Notice of Allowability

10/673,019

PERELLO ET AL.

EXAMINER'S AMENDMENT

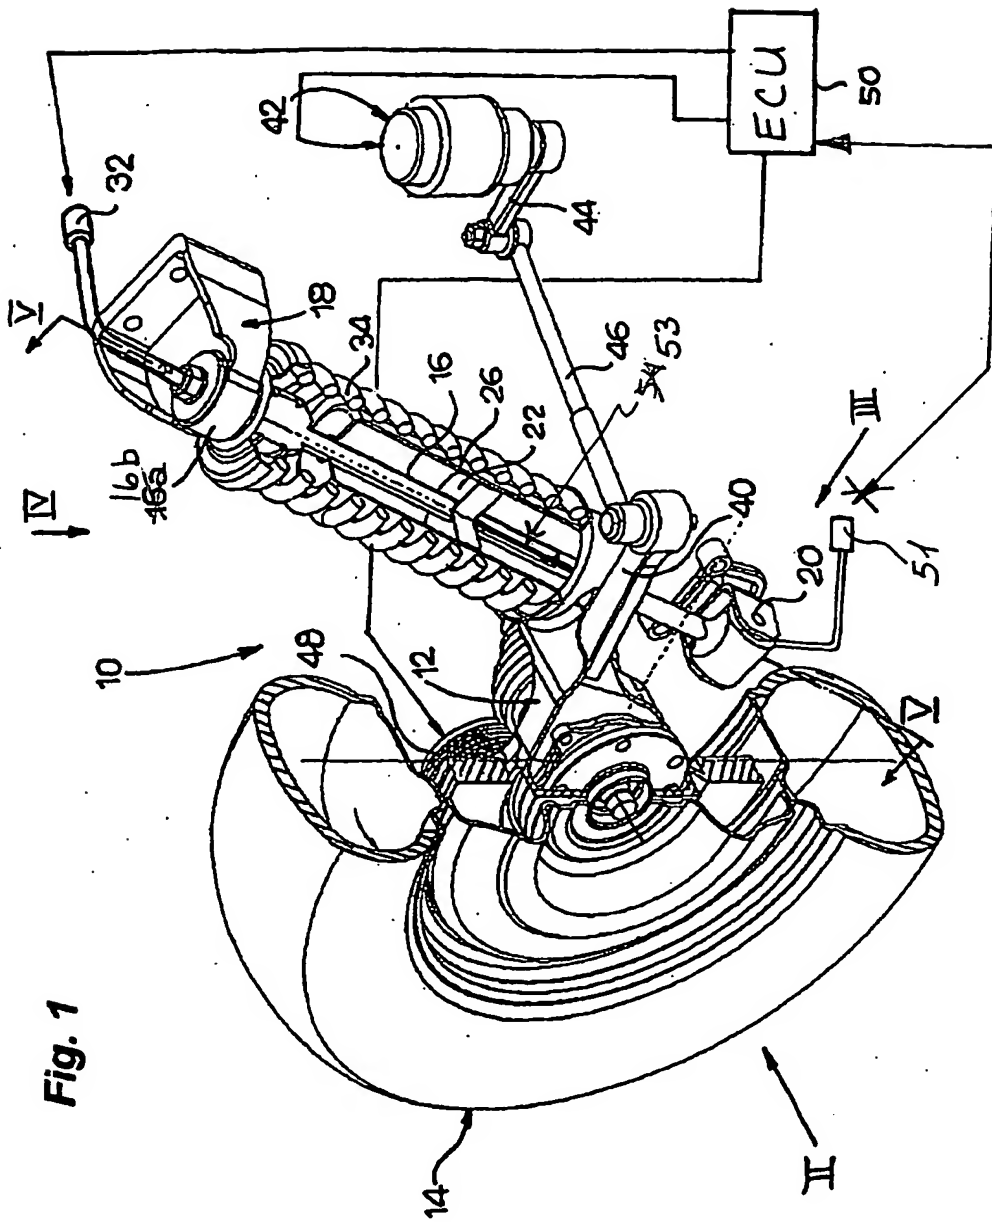
In Figs. 1 and 6, "16a" has been changed to --16b--.

In Figs. 1 and 6, --ECU-- has been inserted in box 50.

In Figs. 1 and 6, the line extending from connector 51 to box 50 has been provided with an arrow adjacent box 50 instead of adjacent connector 51.

In Figs. 1 and 6, "54" has been changed to --53-- and the associated lead line has been provided with an arrow.

See the attached marked-up copies of Figs. 1 and 6 showing the above changes.
